ADDENDUM ONE

Project: **Sullivan County Immunization**

November 11, 2022

This Addendum is part of the Contract Documents for the above referenced project and modifies the original drawings and/or specifications, dated **10/27/22**, as noted below. The bidder shall acknowledge receipt of this Addendum in the place provided in the Bid Form. The published bid date and time shall remain the same.

CANOPY
DETAILS

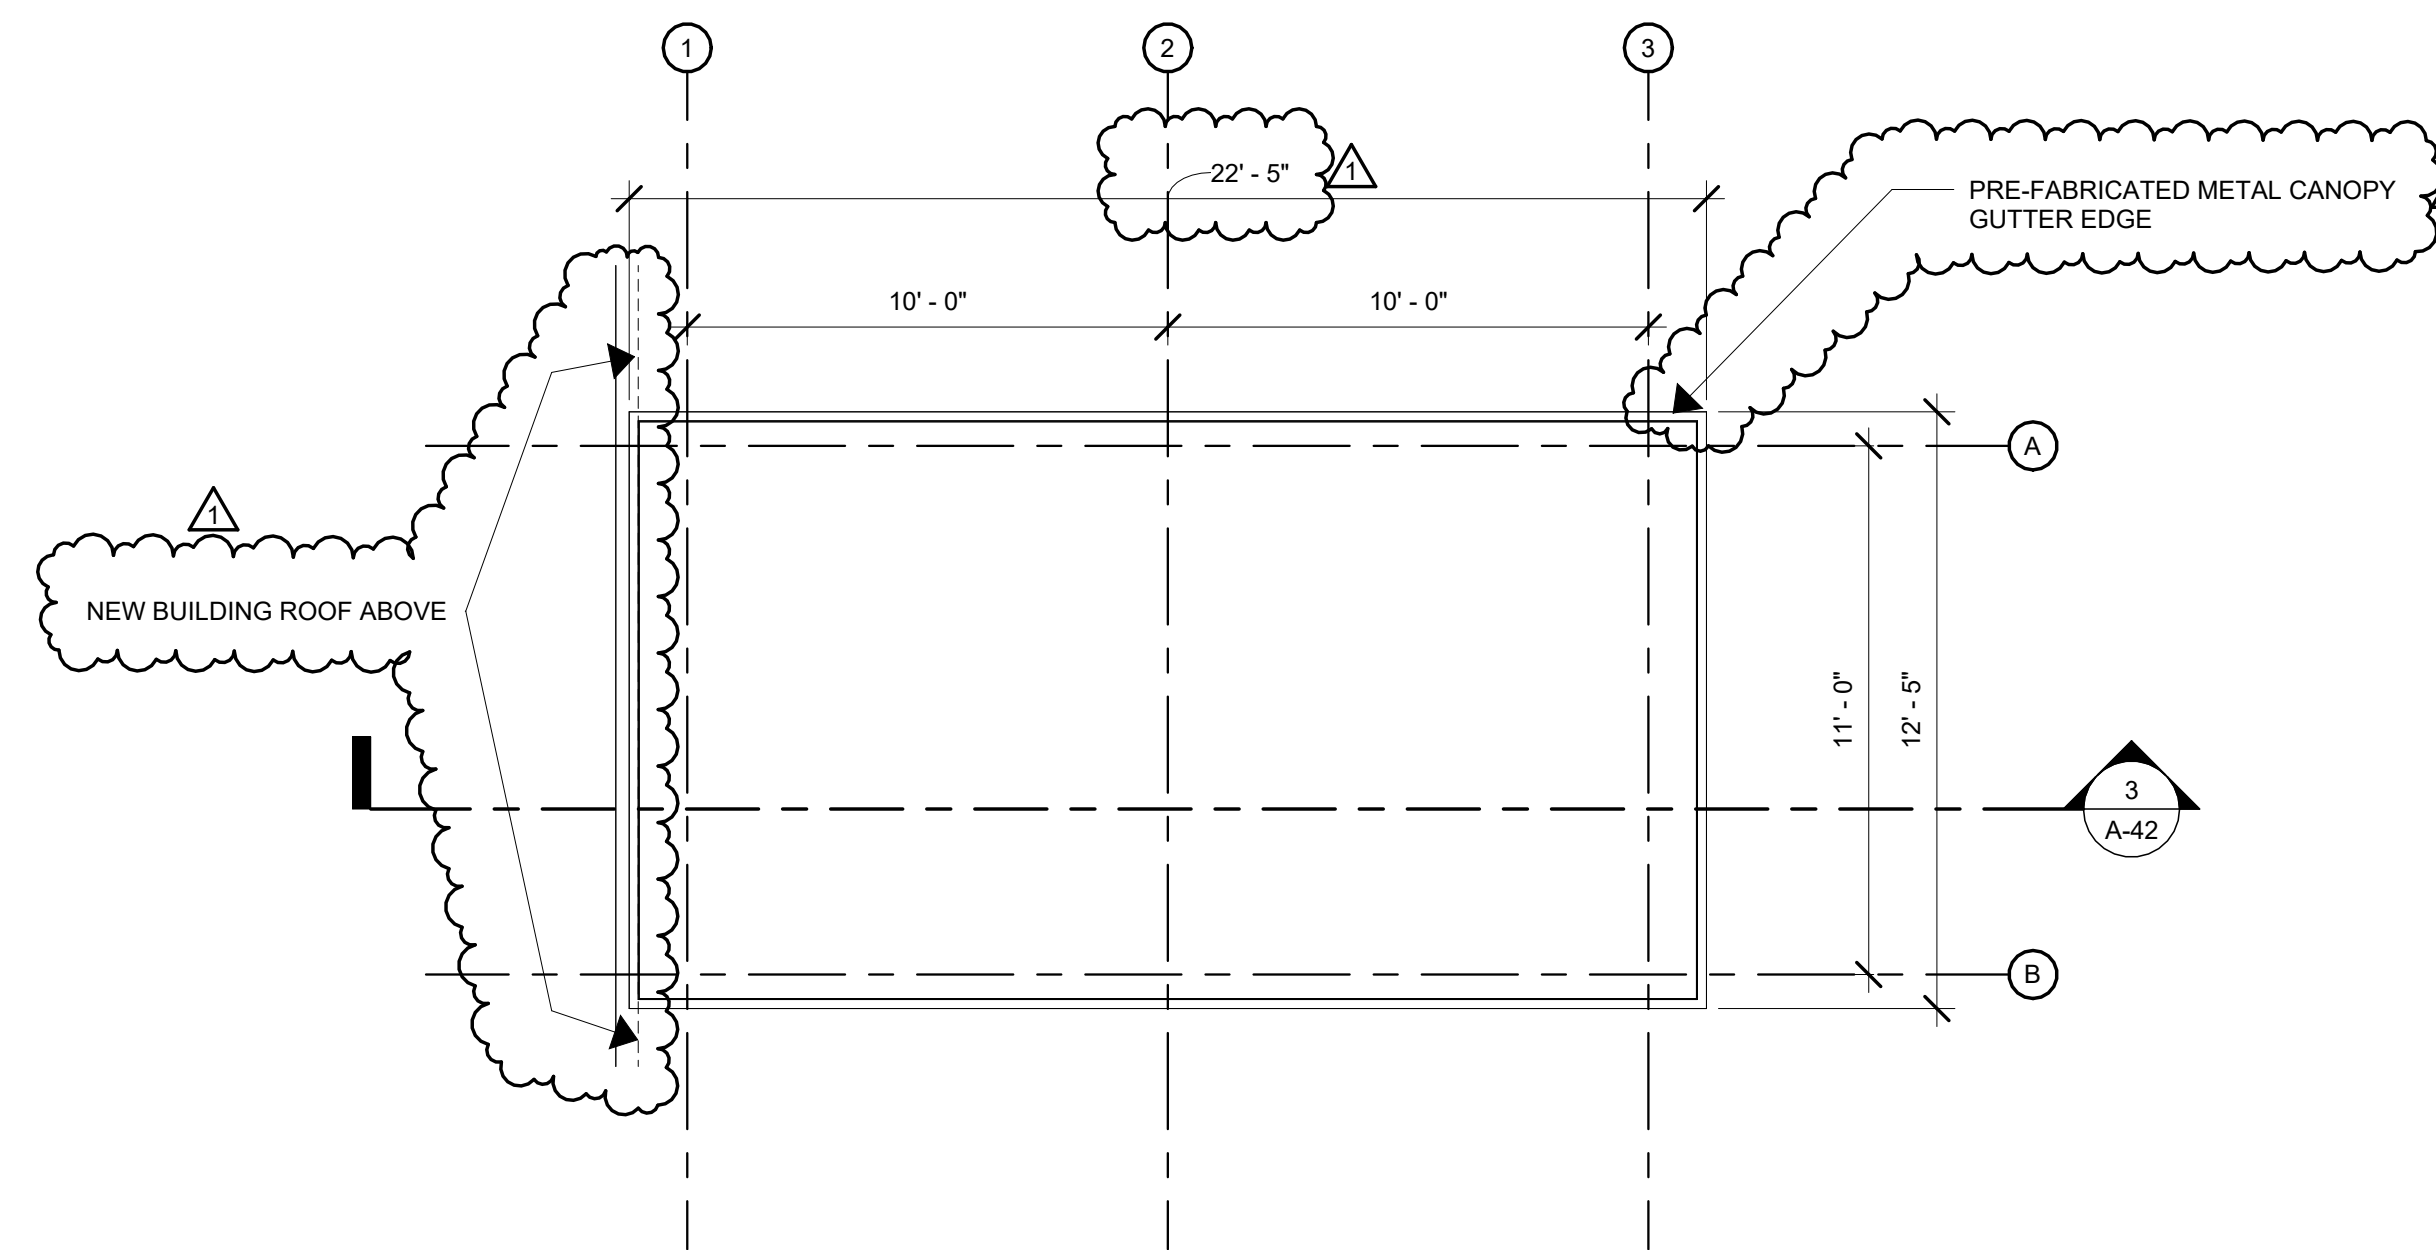
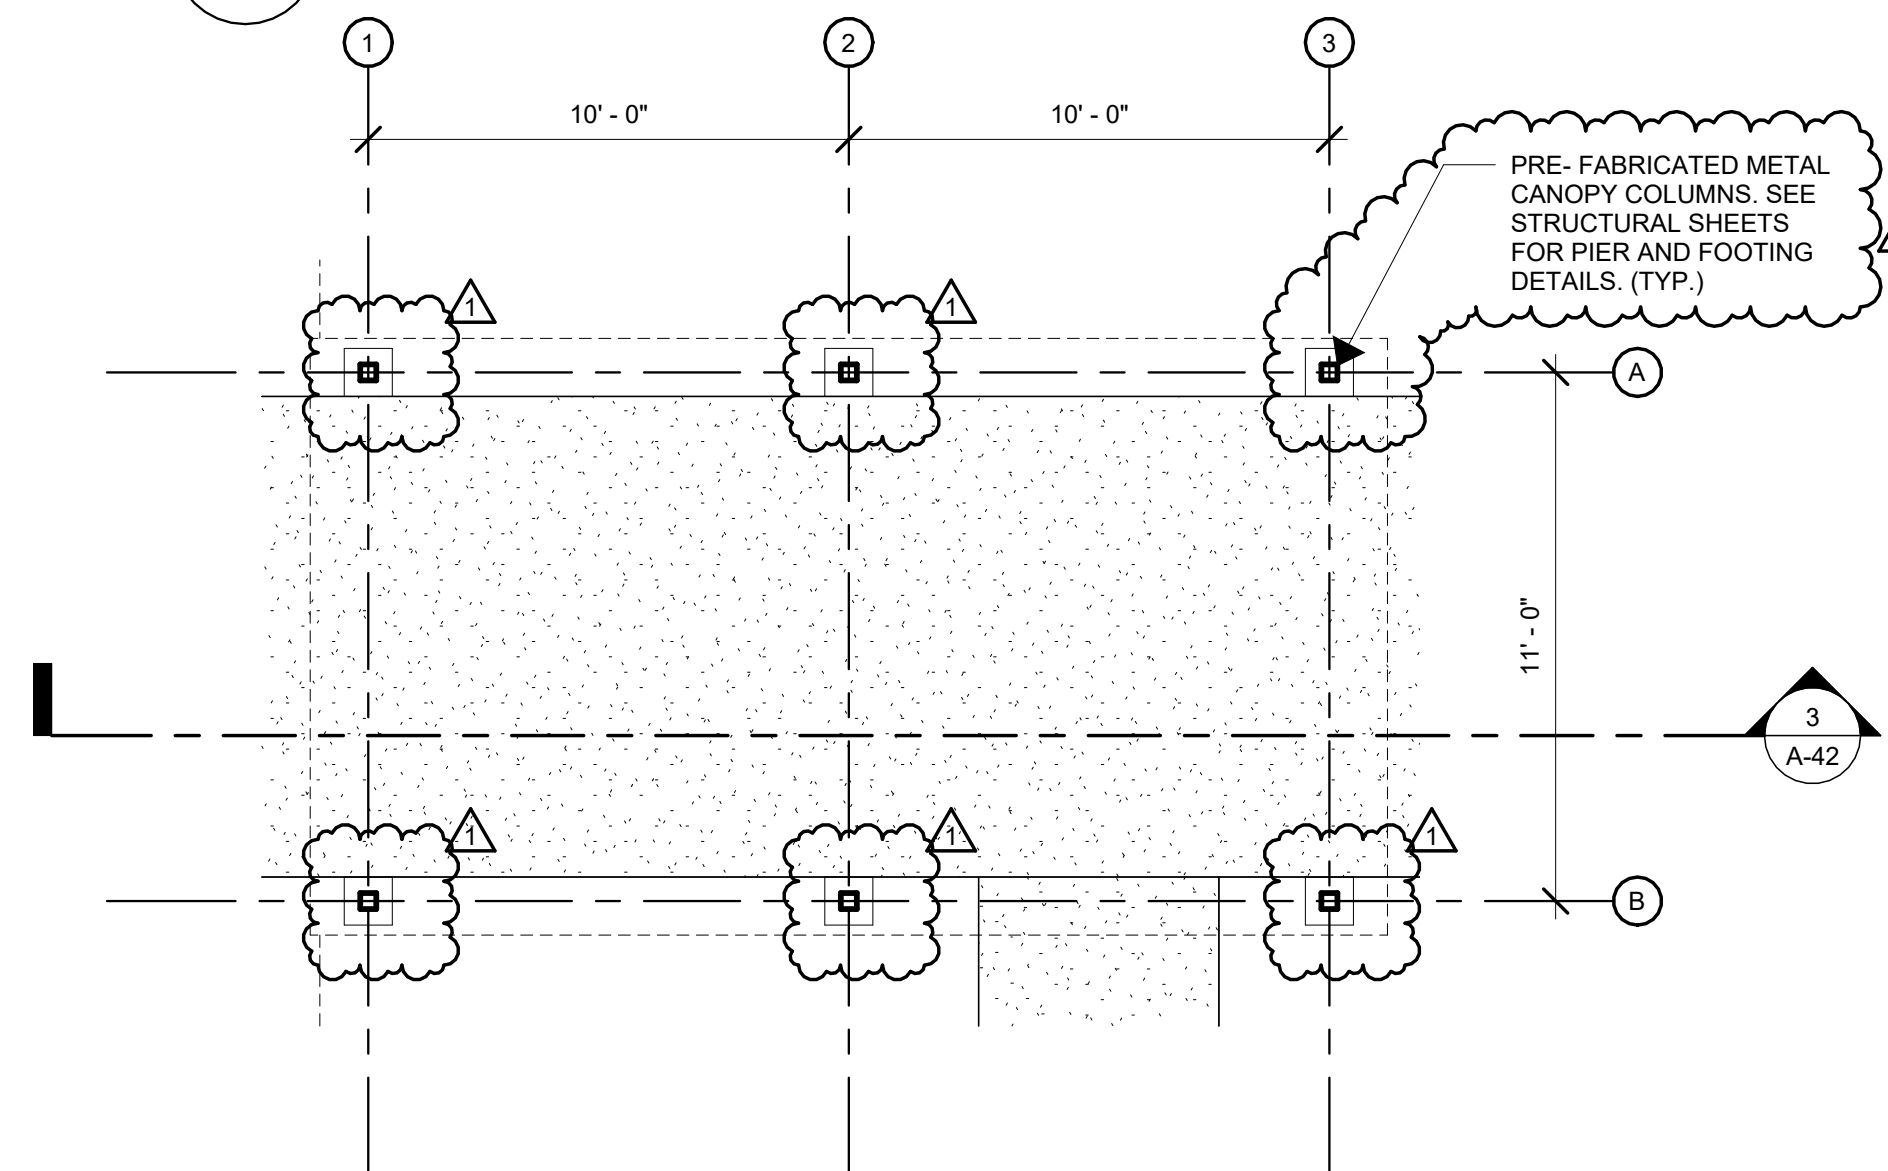
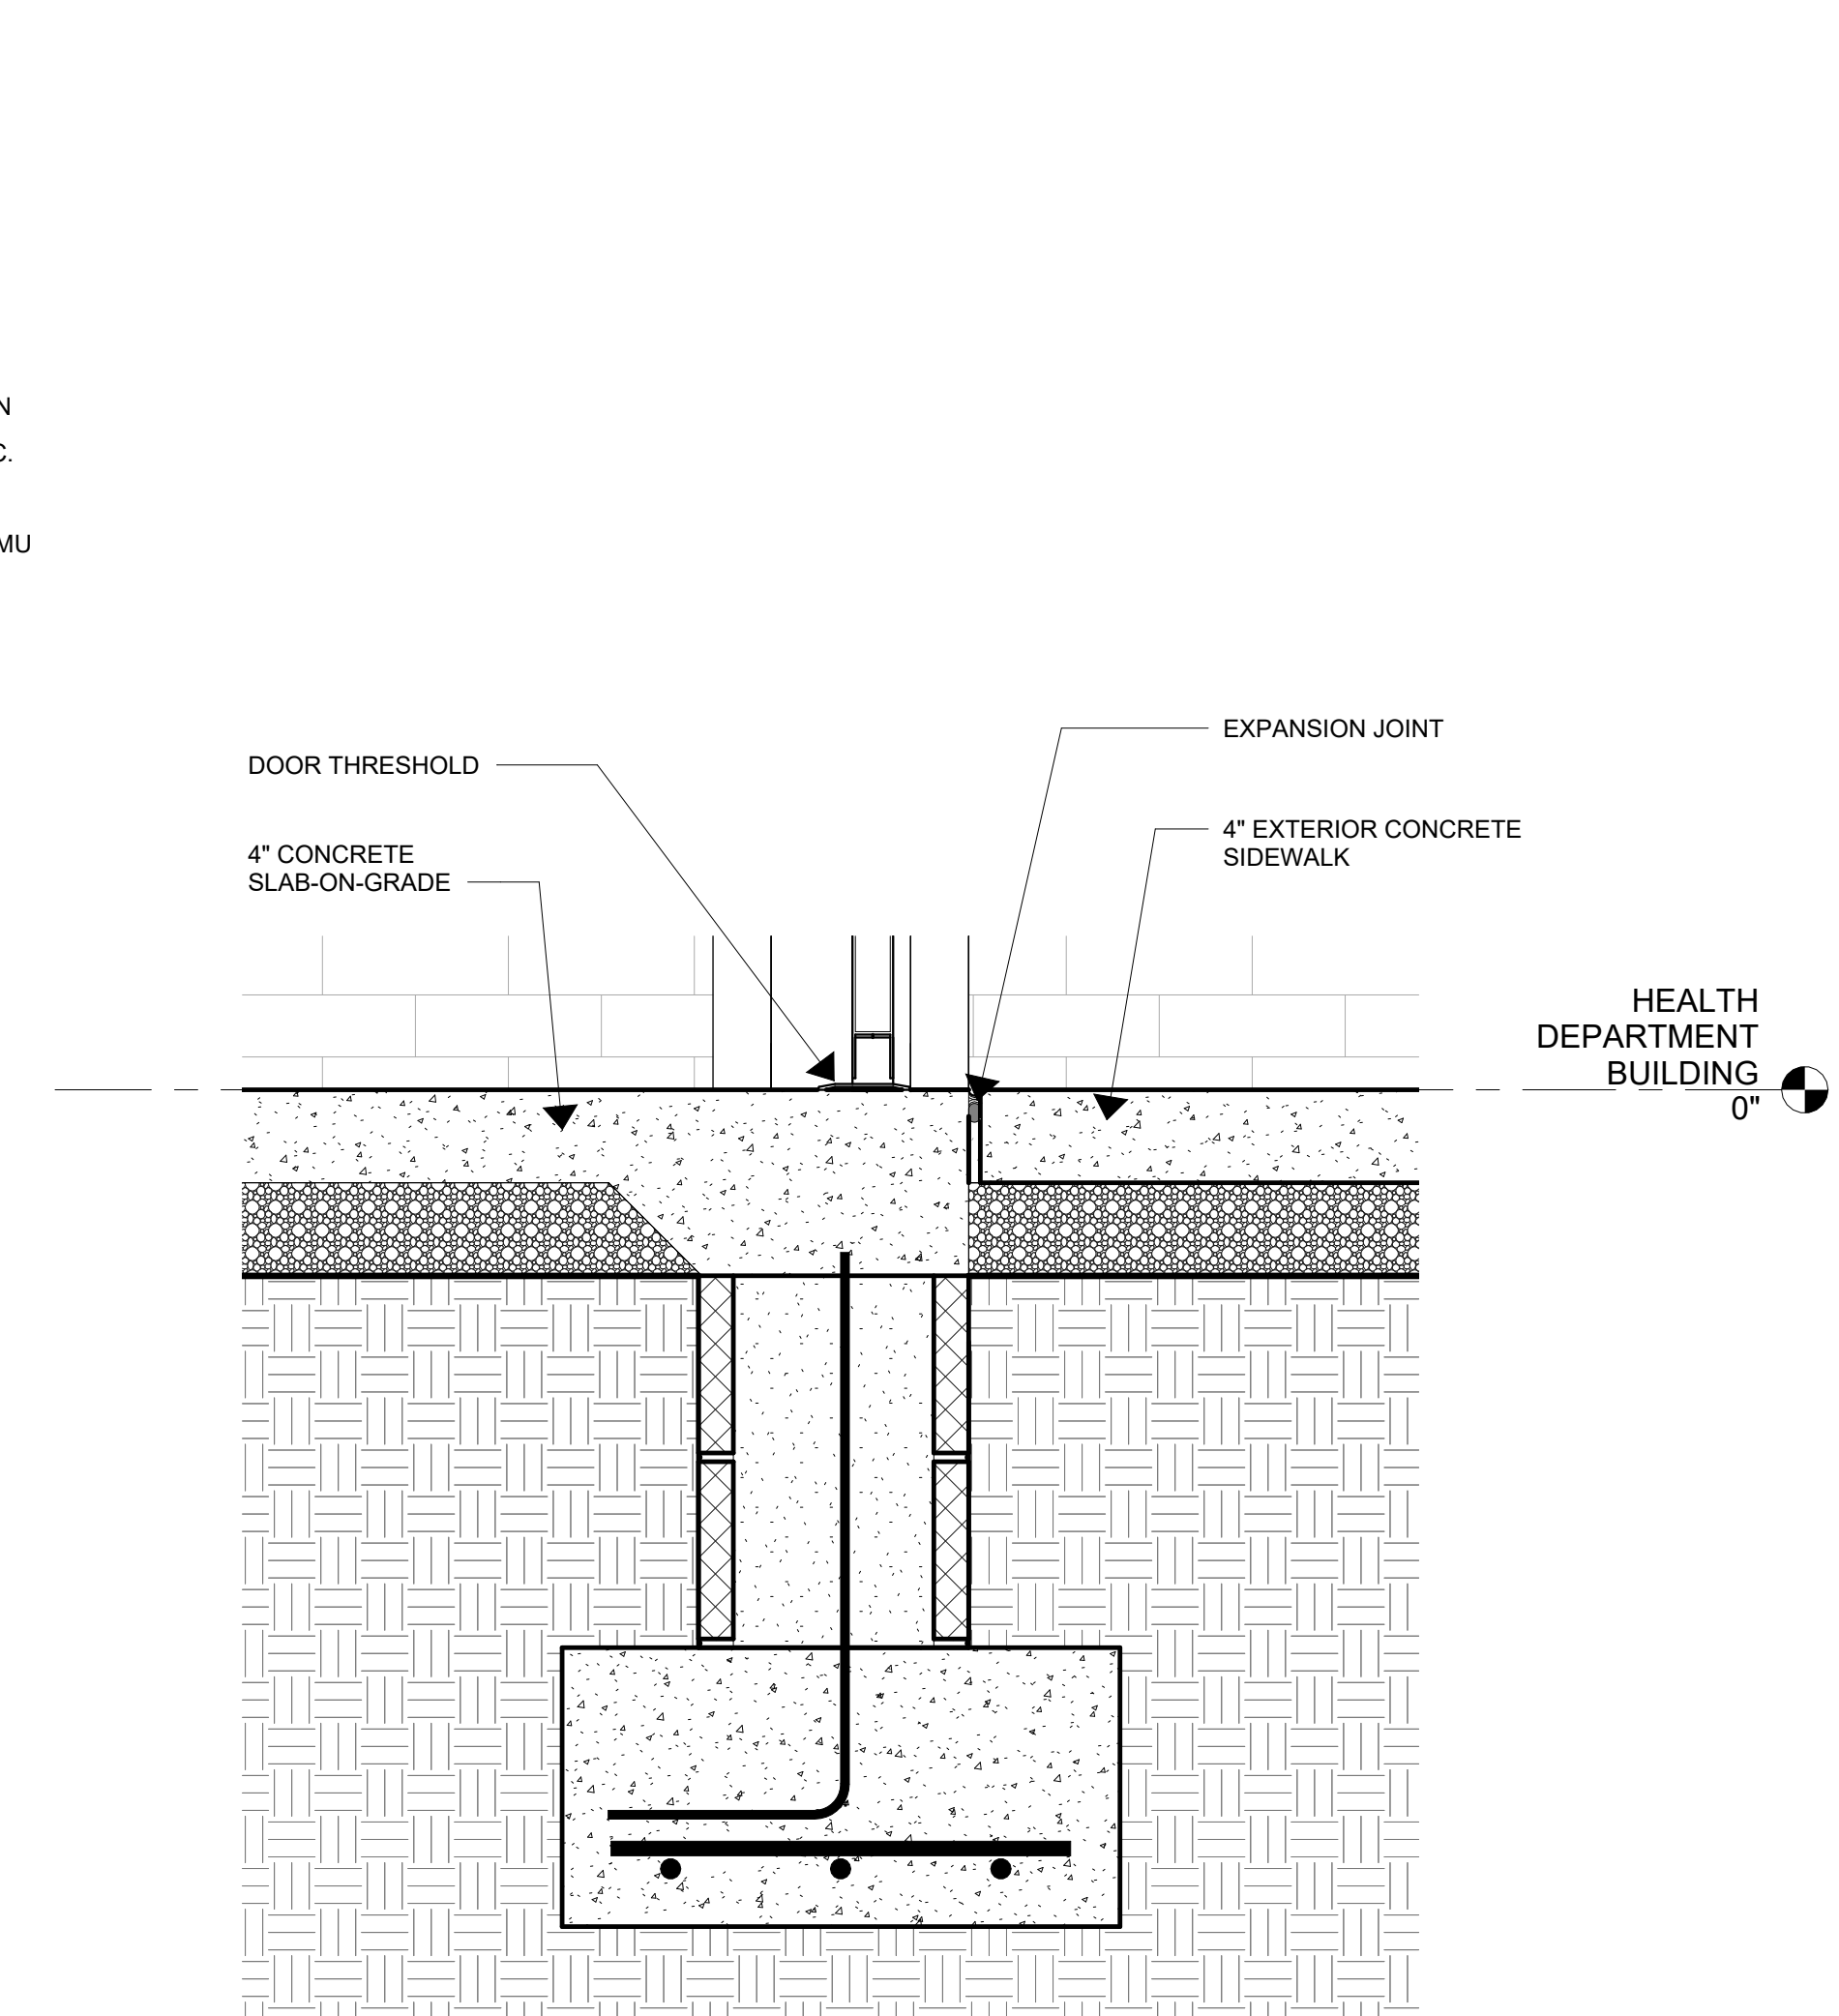
14. **Sheet A-35- Building Sections - Detail 4/A-35** - Missing brick angle over door, added notes.
15. **Sheet A-42 Canopy Details** - added notes.
16. **Sheet A-51 Details** - added signage detail.

FRAME TYPES

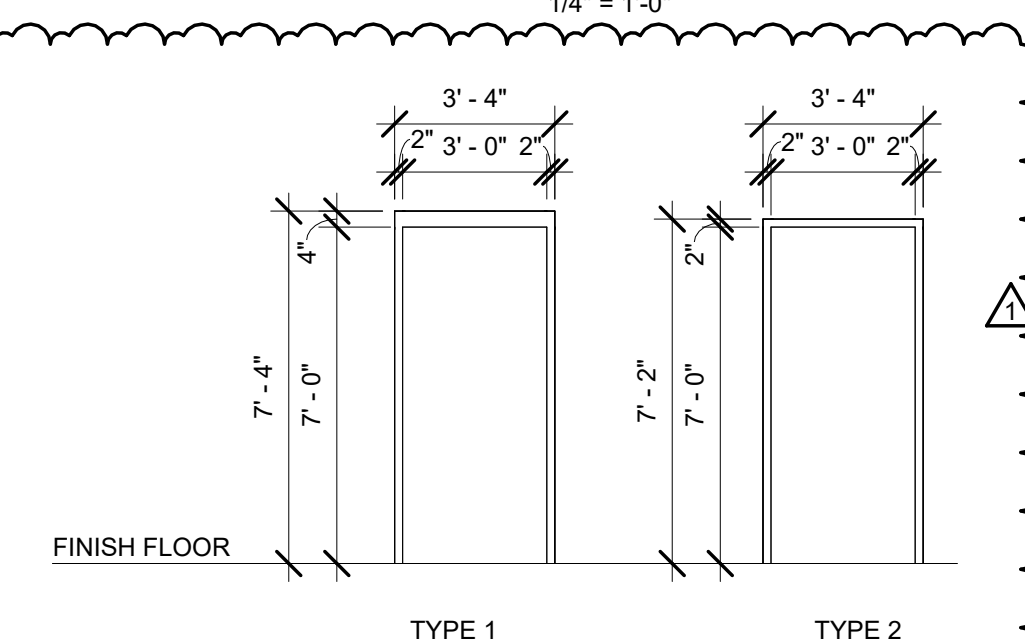
17. **Sheet A-61 Door Window Schedule - Base Bid** – added frame type details.
18. **Sheet A-63 Door Window Schedule – Alt. 2** – added glazing types.
19. **Sheet I-21 Reflected Ceiling Plan – Base Bid** – added ceiling mounted receptacle.
